HIGH VOLTAGE TRANSFORMER
SECONDARY VOLTAGE INCREASED
TO INSURE TRACE CUTOFF

M457

TIME BASE GENERATOR AND TRIGGER
FAST SWEEP SPEED LINEARITY AND
STABILITY IMPROVED BY CHANGING
VARIOUS COMPONENTS

M474B

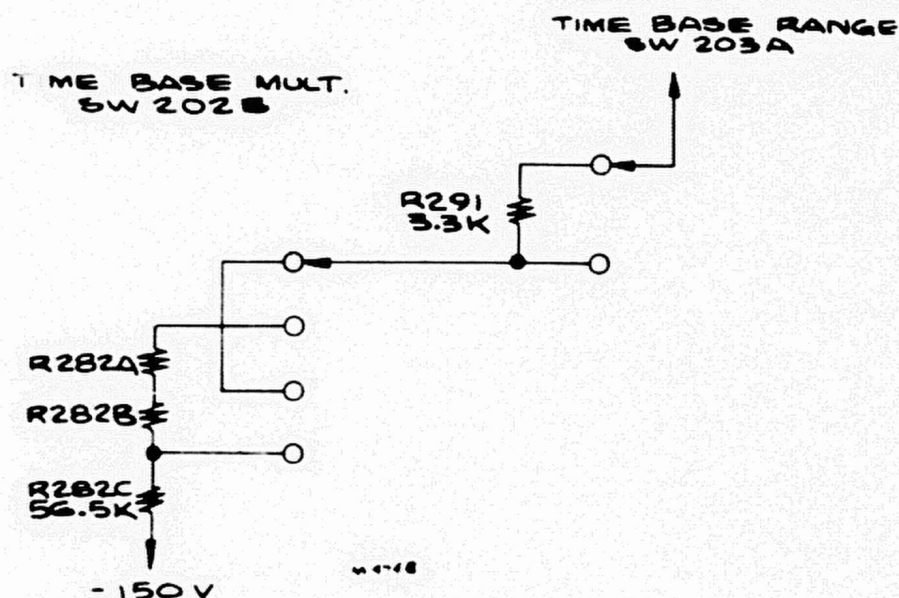
Various components in the Time Base Generator were changed to improve sweep linearity and sweep and trigger stability at fast sweep speeds.

C272	22 pF cer	281-0510-00
C276	3-12 pF var	281-0007-00
C300	5-25 pF var	281-0010-00
C303	4.7 pF cer	281-0501-00
R282C	60k 1/2 W 1%	309-0067-00

C272	47 pF cer	281-0518-00
C276	1.5-7 pF var	281-0006-00
C303	0.5-5 pF var	281-0001-00
R282C	56.5k 1/2 W 1%	309-0040-00
R291	3.3k 1/2 W 10%	302-0332-00

- C272 (at pin 1 of V213A) from 22 pF to 47 pF
- C276 (at pin 6 of V214B) from 3-12 pF to 1.5-7 pF
- C303 (at pin 3 of V224A) from 4.7 pF to 0.5-5 pF
- R282C (on Time Base Multiplier switch) from 60k to 56.5k 1%
- Remove C300 (near V222)
- Add R291 to Time Base Range switch as shown in schematic

M498

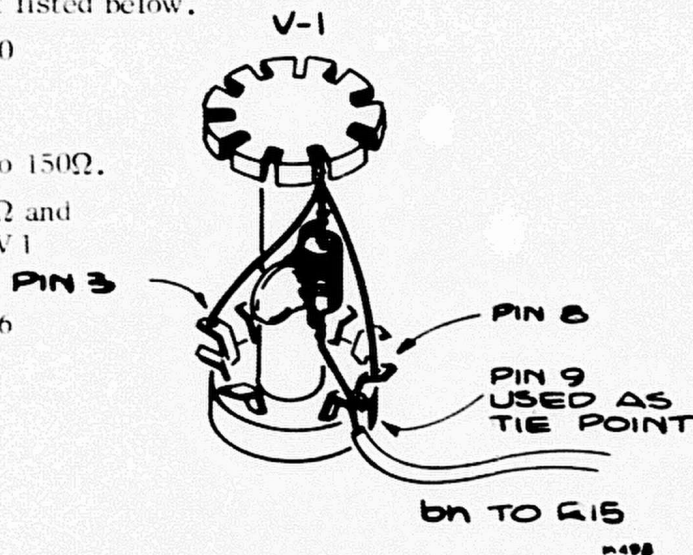
Preamplifier transient response improved by:

1. Adding an RC time constant in series with R15
2. Removing R19 (reinstalled in M507)
3. Changing value of R36
4. Adding a plate decoupling cap to V2B. Install M507 at same time.

- a) Change R36 (across L2) from 220 Ω to 150 Ω .
- b) Install a network of R16 and C16 (10 Ω and 0.02 μ F in parallel), in series with V1 cathode lead to R15. See drawing.
- c) Install C13, 0.01 μ F discap from pin 6 of V2B to ground.
- d) Recalibrate Vertical Preamplifier.

M539-1

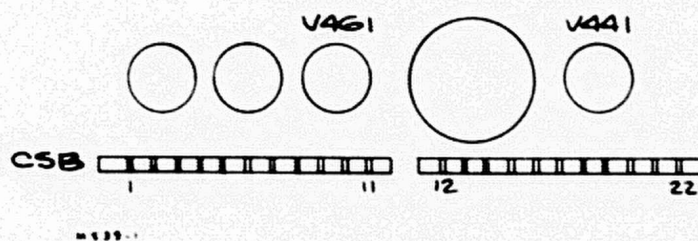
Improve stability of the Vertical Amplifier when in the preamp position by increasing the time constant in the grid circuit of the voltage regulator feedback amplifier in the +225 V and +350 V supplies.

- Remove wires between CSB-11, 12 and 13.
- Replace tubing covered wire, between pin 1 of V461 and CSB-11, with a 2.2 M 1/2 W resistor (R469).
- Add a length of bare wire between CSB-11 and CSB-13 (dress this wire away from CSB-12).
- Remove bare wire between CSB-18 and CSB-19.
- Add a 2.2 M 1/2 W resistor (R446) between pin 1 of V441 and CSB-19.
- Check accuracy of +225 and +350 V supplies.

FIG. 1

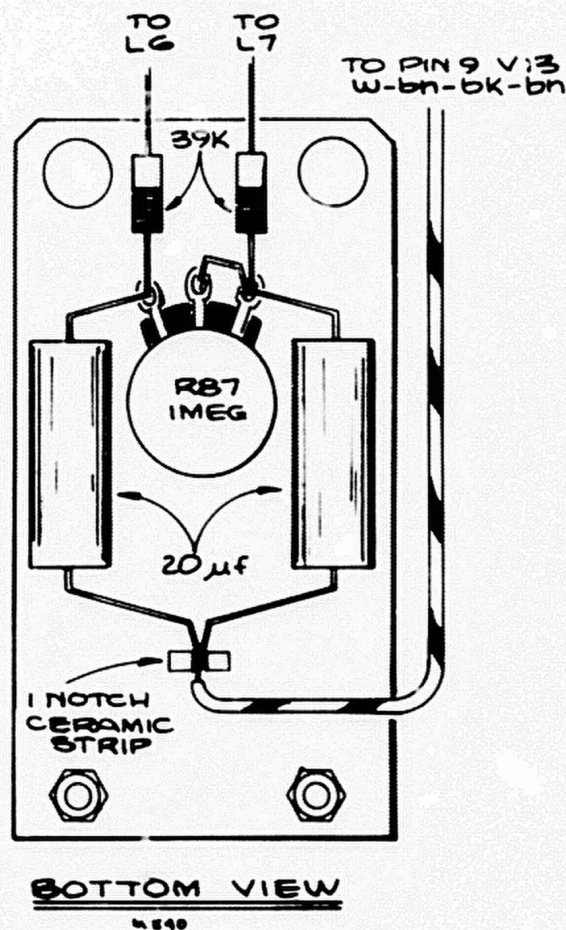
To compensate for vertical DC shift, add an LC network to the plate circuit of the Vertical Amplifier output tubes.

- Mount and wire parts on mounting plate 386-0323-00 as indicated in Fig. 1.
- Change R80 (at L4 and L6) and R84 (at L5 and L7) from 2.5 k 10 W to 2.7 k 10 W.

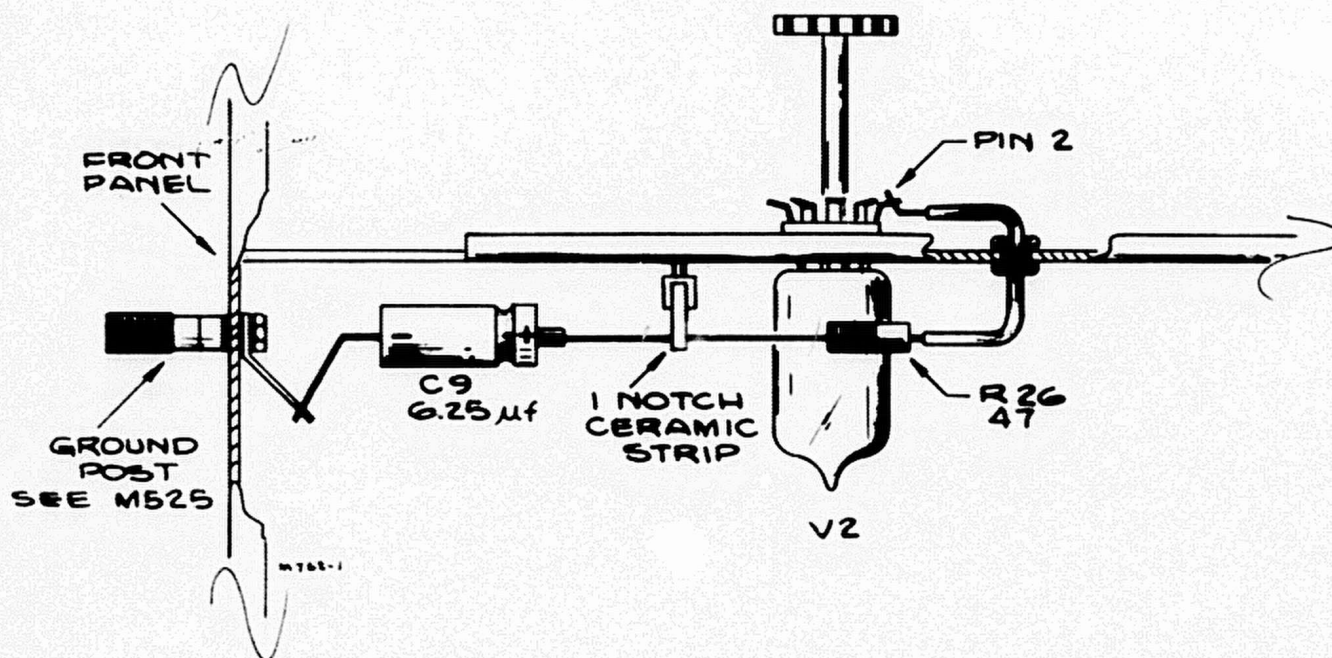
Refer to drawing and rewire C 9, (6.25 μ F) and add R 26 (47 Ω).

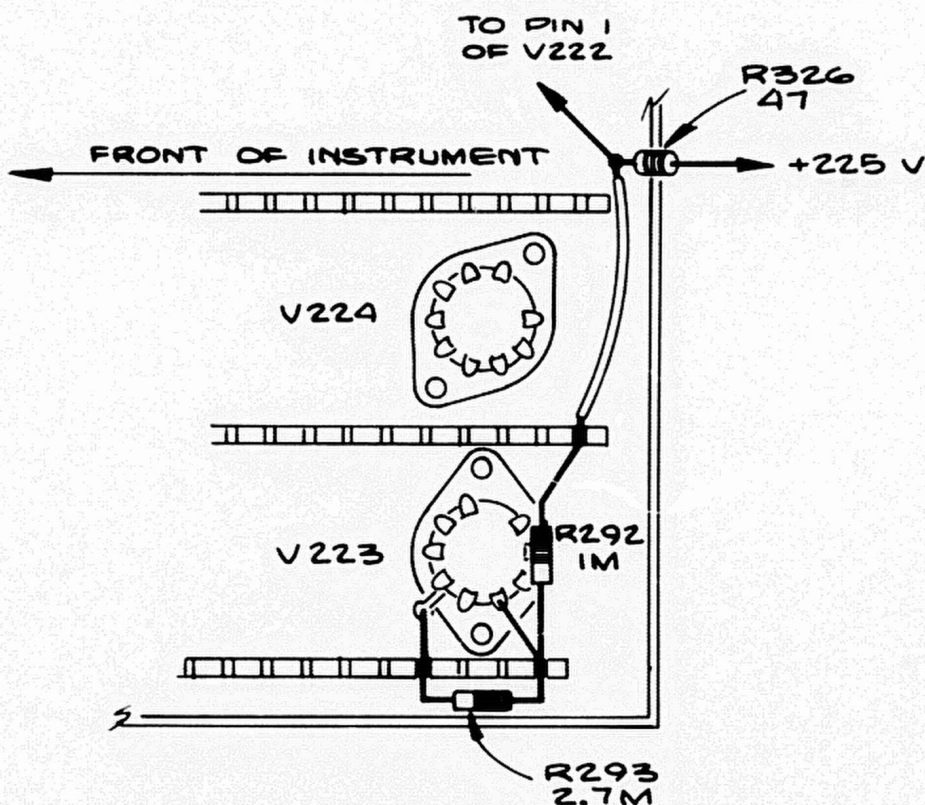
R292	1 M 1/2 W 10%	302-0105-00
R293	2.7 M 1/2 W 10%	302-0275-00

- Remove strap between V442, pins 3 and 8.
- Remove strap between V442, pin 8 and 270 k 1/2 W resistor - white-red-red-black wire junction.
- Add strap between V442 pin 3 and 270 k 1/2 W resistor - white-red-red-black junction.
- Add R292, 1 M and R293, 2.7 M as shown in drawing on next page.

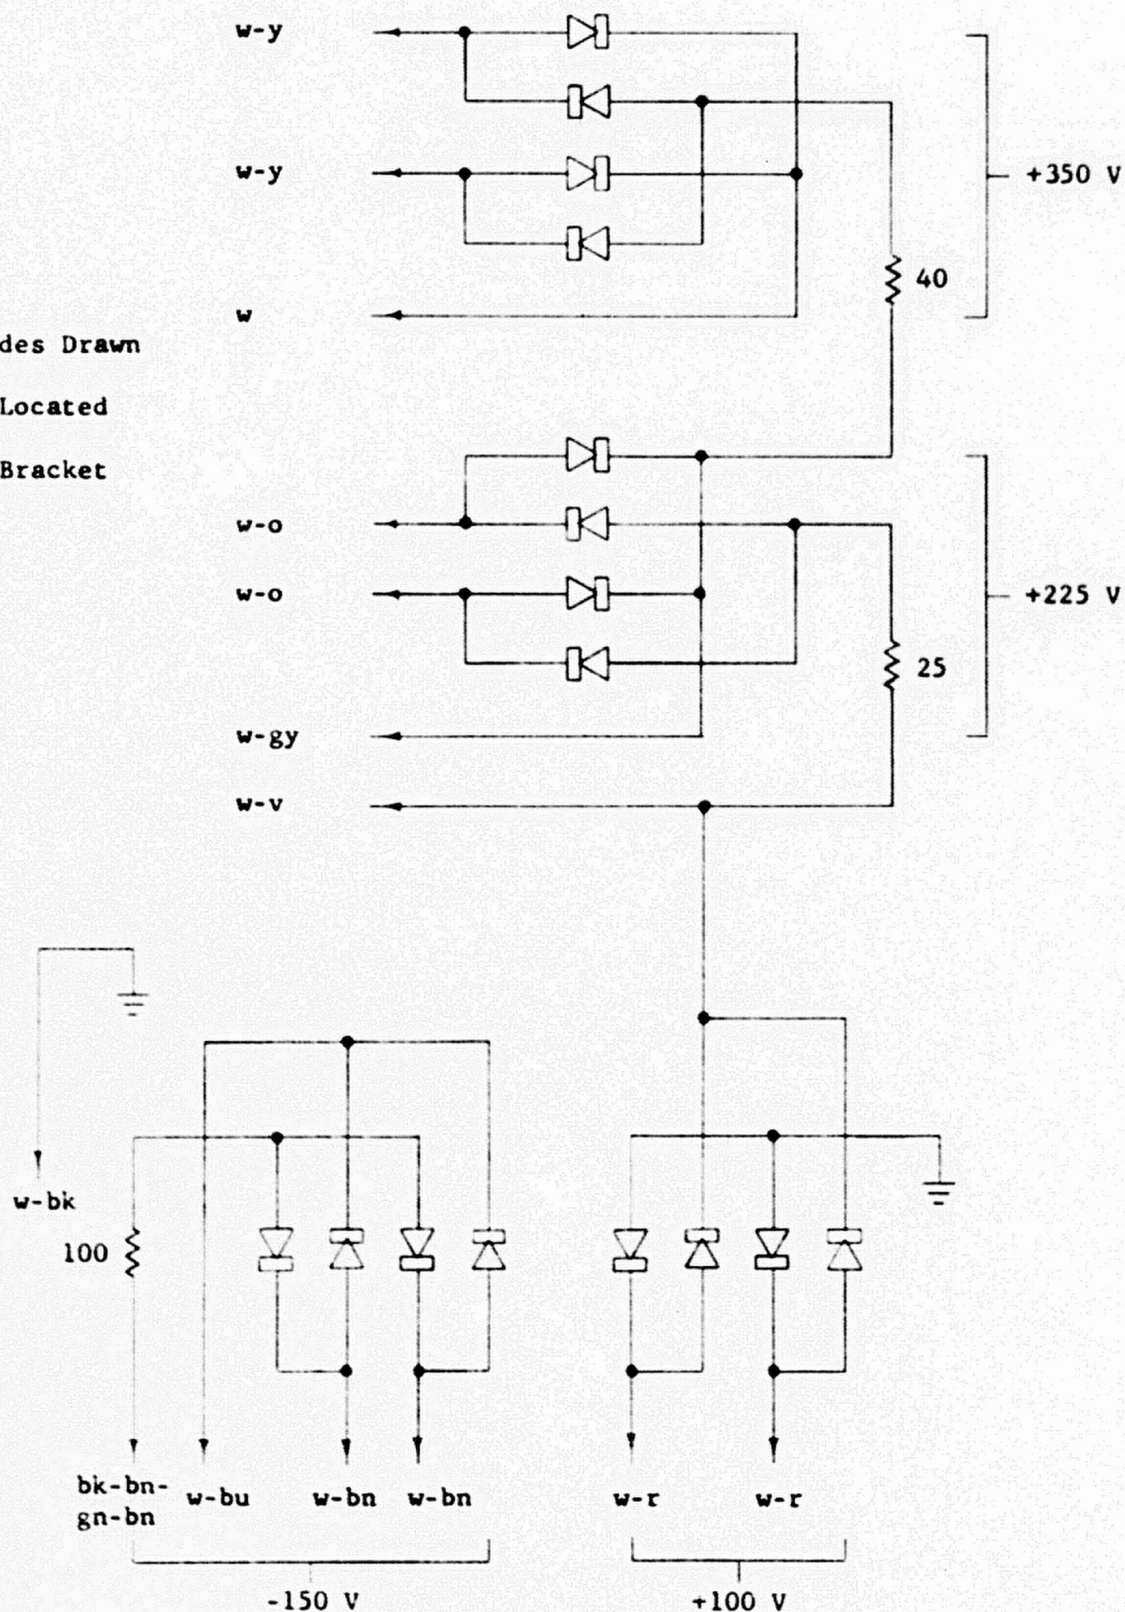
- () 1. Remove the selenium rectifier mounting plate from the instrument.
- () 2. Unsolder all wires to the selenium rectifiers.
- () 3. Temporarily mount the silicon rectifier assembly on the back panel of the instrument (as shown in Fig. 2) with the two 6-32 x 5/16 screws from the kit.

- () 9. Solder the wires to the ceramic strips, as shown in Fig. 2.
- () 10. Locate R443 and R465 (top of instrument, at rear). Replace them with the resistors (from kit) indicated below. Use the old mounting hardware.

- () R443 -- replace the 3.5k 20W WW resistor with the 2.4k 20W WW resistor.
 - () R465 -- replace the 1.5k 25W WW resistor with the 1.8k 25W WW resistor.

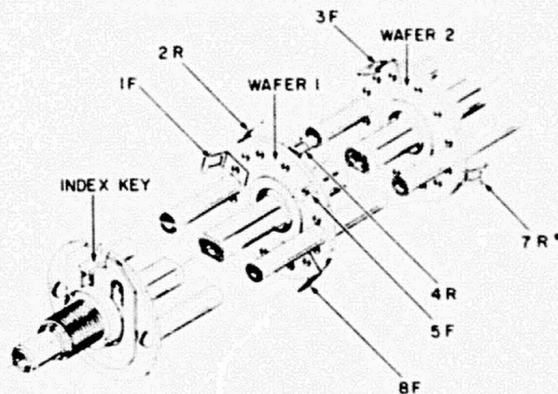
NOTE: The following method is used to identify the RANGE SWITCH terminals:

Contact positions are numbered 1 through 12 relative to the index key as shown in drawing.

Example: W2-7R (denoted by * on drawing) is contact #7 on the rear of wafer 2.

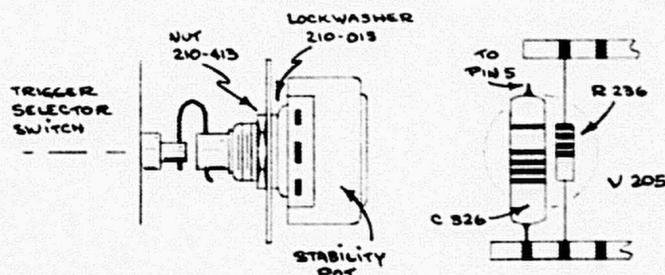
NOTE: On some instruments it may be necessary to temporarily relocate some components mounted on the ceramic strips directly behind SW201. Unsolder C326 from out board ceramic strip and push it down on the chassis between the socket of V205 and the switch. Unsolder R236 from out board ceramic strip and move it out of the way. See drawing.

- () 2. Remove old potentiometer and hardware.
- () 3. Install new potentiometer, hardware and coupling (all from kit) as shown in drawing, tighten nut and replace knobs. Replace inner shaft with shaft from kit, if necessary.

NOTE: Due to different spacing on the switch wafers it may be necessary to mount the pot using a nut on each side of the Switch plate. If so use the thin lockwasher (210-012) from kit.

Fig. 1

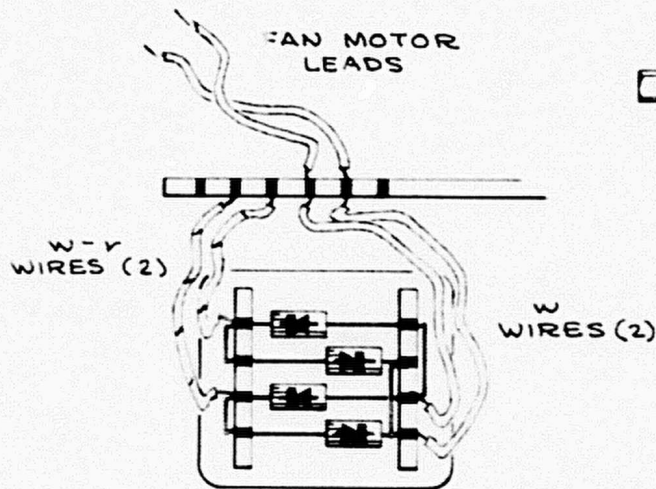
- () 1. Replace the selenium rectifier on the power chassis with the assembly from the kit. Position the assembly as shown in Fig. 1. Use a lockwasher (from kit) between the assembly and the chassis.
- () 2. Solder the two white and two white-red wires (from kit) between the assembly and the adjacent ceramic strip as shown in Fig. 1.
